## Design Review Committee Meeting

Wednesday, April 27, 2016

### DRAFT - MEETING MINUTES

### MXD INFILL DEVELOPMENT CONCEPT PLAN – LAND USE AND MASSINGS

**ADAPTATIONS TO ARTICLE 14 – APPROACH A.**

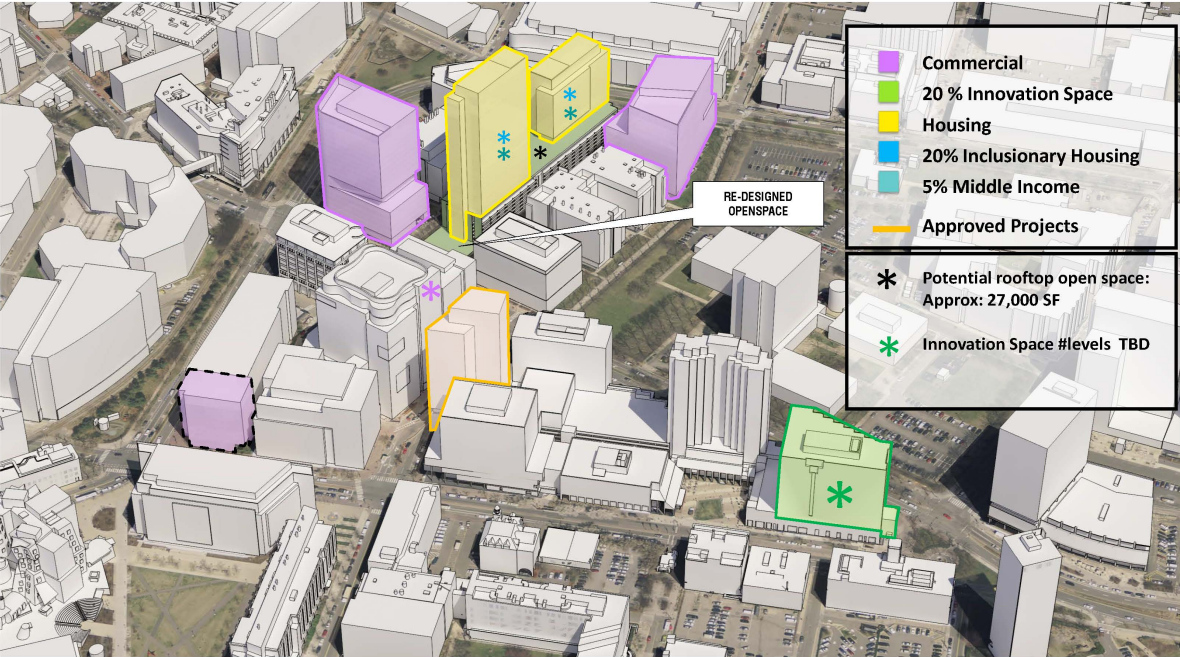
Mr. Visgaitis talked about the three approaches. One approach has the residential building closer to Binney. Approach A has a view corridor to the Volpe site. In response to Mr. Crawford, the Porkchop Park would be viewable in the residential building's upper levels.
